Date: January 23, 2013

From: Cary Teague, Community Development Director

Re: Acres Dubois – “Sketch Alternatives”

Original Plan – With Revision

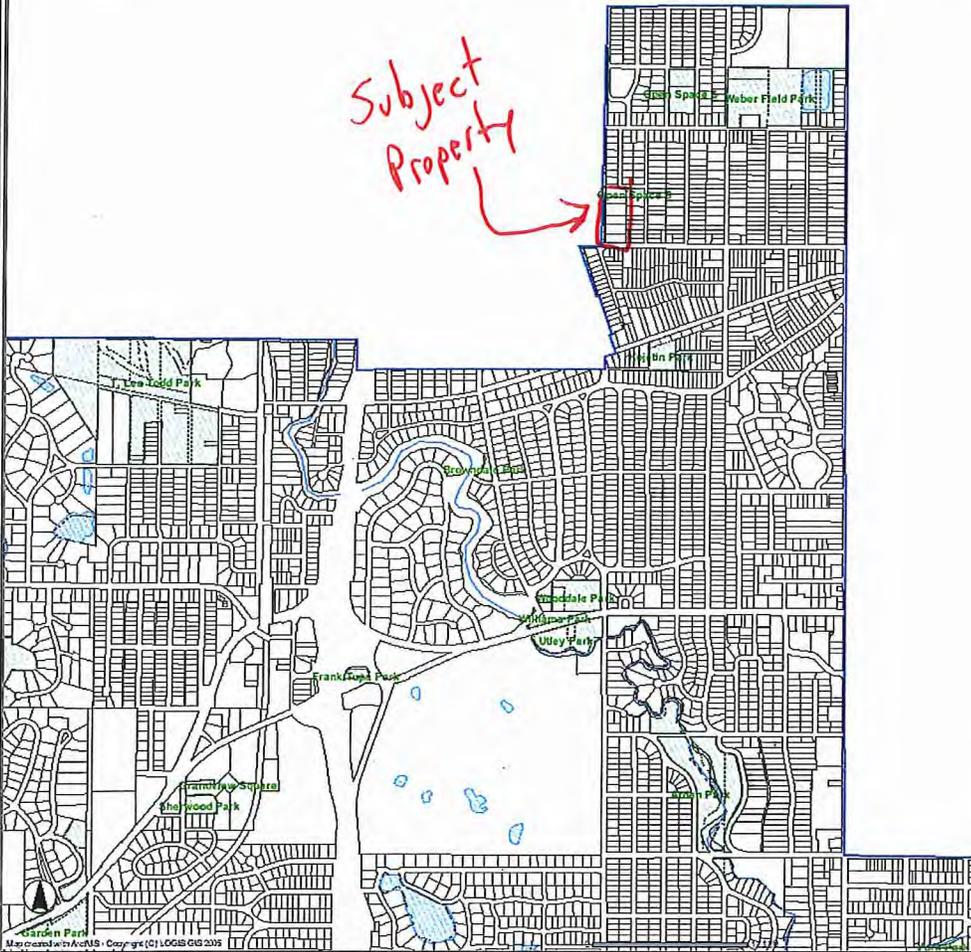
Please note that the revision to the original plant in this option is that the right-of-way has been reduced from 50 to 40 feet wide, and the street width has been narrowed from 28 feet to 24 feet. (See page A8.)

The City’s public works director has expressed concern over the pervious pavers located at the end of the cul-de-sac. A vacuum street sweeper would be required for proper maintenance; and the City does not have that type of equipment.

The City’s fire chief has indicated a preference of at least a 24-foot wide street to enable their equipment to be able to turn around and get through during the winter months. A portion of the 24-foot wide street could however be shared with a 6-foot sidewalk designation. With a 24-foot wide street, the homes would have to be constructed with sprinkler systems, and parking would only be allowed on one side of the street. If this road were a private street, the Fire Code would require a minimum street width of at least 20-feet.
